CONSOLIDATED RESPONSE TO AGENCY AND PUBLIC SUBMISSIONS (PARTS A, B and C)

PROJECT APPLICATION SANDON POINT

Don Fox Planning Pty Ltd

NOVEMBER 2008

Typical Sections Through Hewitts Creek Railway Diversion Channel

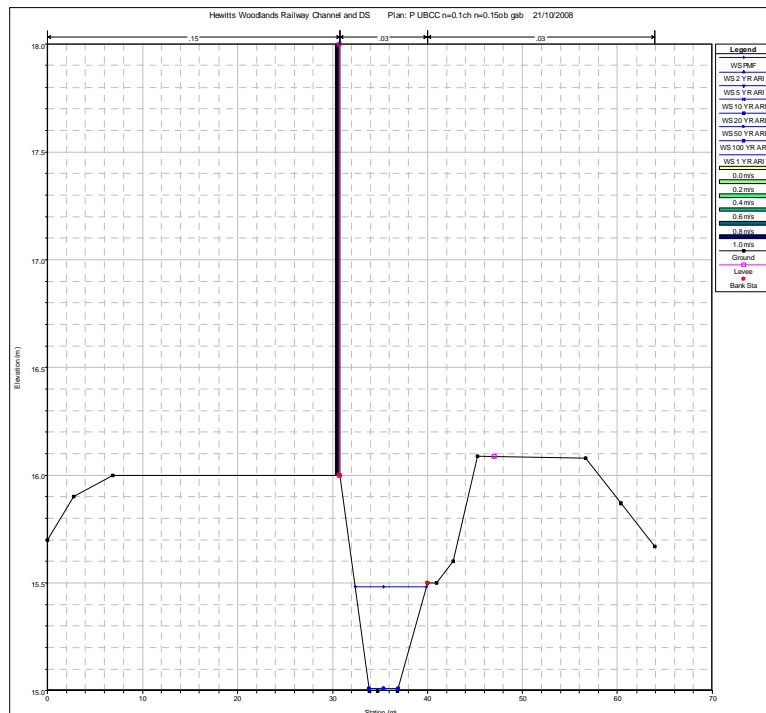
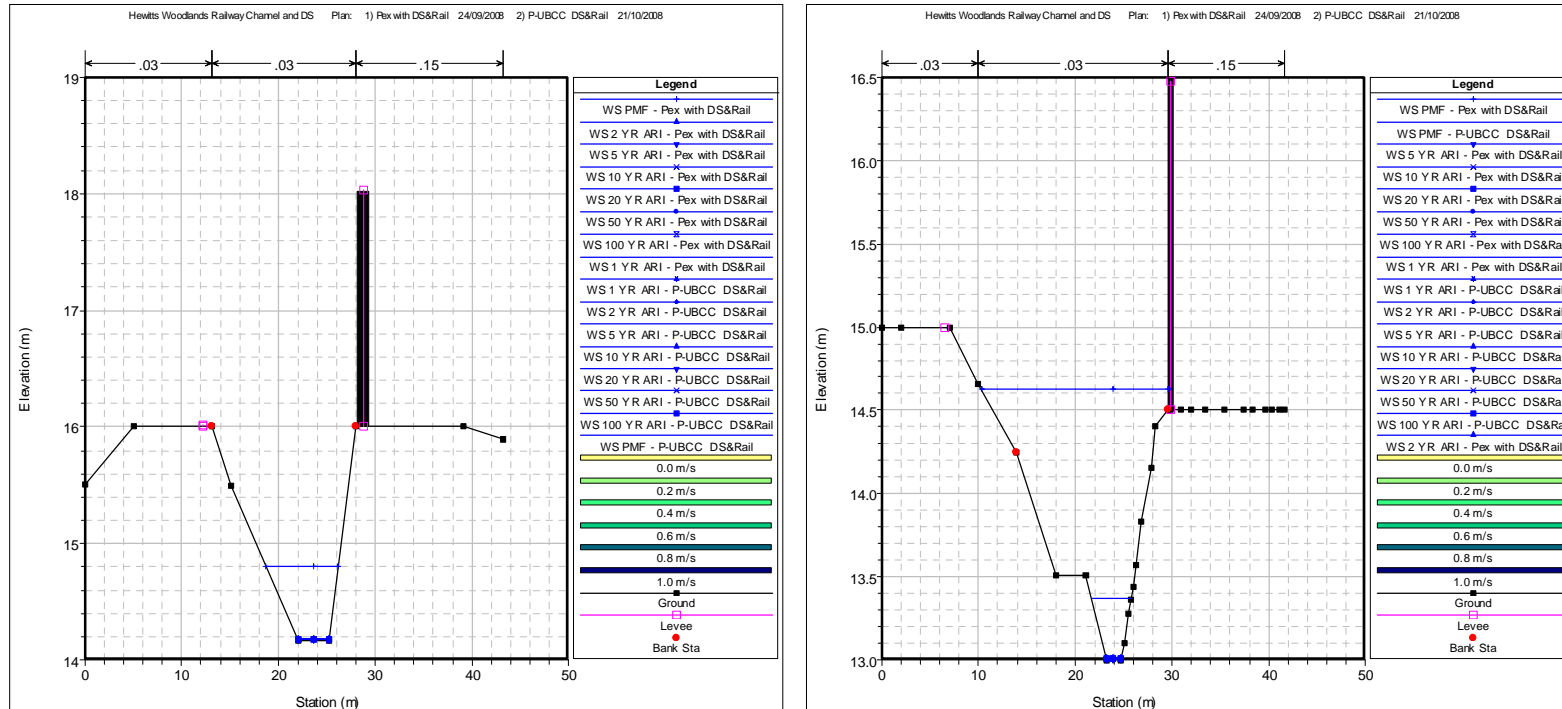
ISSUE 45 The flood study fails to clarify the impact of flooding on the development due to overtopping of the railway embankment in the PMF event. This was identified within the Hewitt's Creek Floodplain Risk Management Study and Plan (2002), but was not explored within the recent CFR Climate Change Study.

Flood waters in railway channels up to the PMF do not affect the proposed lots.
